Project	IEEE 802.16 Broadband Wireless Access Working Group < http://ieee802.org/16 >	
Title	MBS Security Support for PKMv2	
Date Submitted	2004-07-08	
Source(s)	JUNHYUK SONG Samsung Electronics	Voice: +82-31-279-3639 junhyuk.song@samsung.com
Re:	Re: Security Adhoc PKMv2	
Abstract	Proposal for MBS Security Support for PKMv2	
Purpose	Discuss and Adopt as the baseline text	
Notice	This document has been prepared to assist IEEE 802.16. It is offered as a basis for discussion and is not binding on the contributing individual(s) or organization(s). The material in this document is subject to change in form and content after further study. The contributor(s) reserve(s) the right to add, amend or withdraw material contained herein.	
Release	The contributor grants a free, irrevocable license to the IEEE to incorporate material contained in this contribution, and any modifications thereof, in the creation of an IEEE Standards publication; to copyright in the IEEE's name any IEEE Standards publication even though it may include portions of this contribution; and at the IEEE's sole discretion to permit others to reproduce in whole or in part the resulting IEEE Standards publication. The contr

Figure-xxx- MBS MAC PDU Ciphertext Payload Format

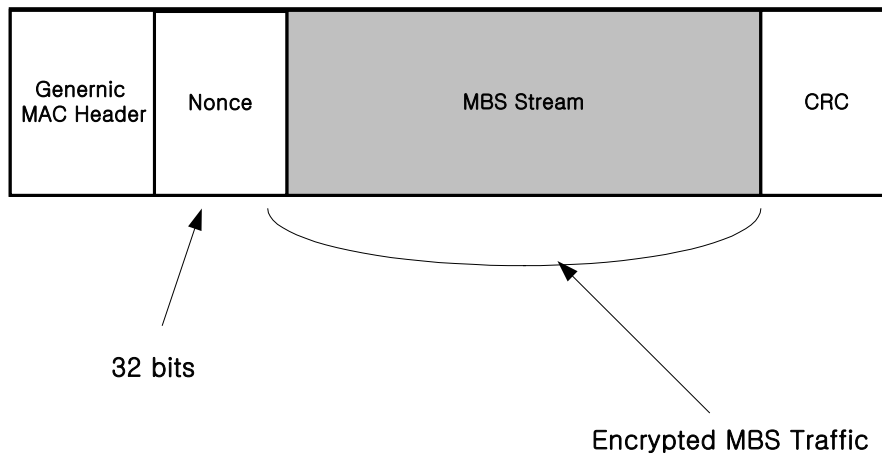
The PDU payload shall be appended with a 32bits nonce randomly generated by base station. The nonce shall be transmitted in little endian byte order. The nonce shall not be encrypted.

The nonce shall be repeated four times to construct 128bits nonce. (Ex. NONCE|NONCE|NONCE|NONCE)

The plaintext PDU shall be encrypted using the active MBS_Traffic_key (MTK) derived from MAK and MGTEK, according to CTR specification.

The processing yields a payload that is 32bits longer than the plaintext payload.
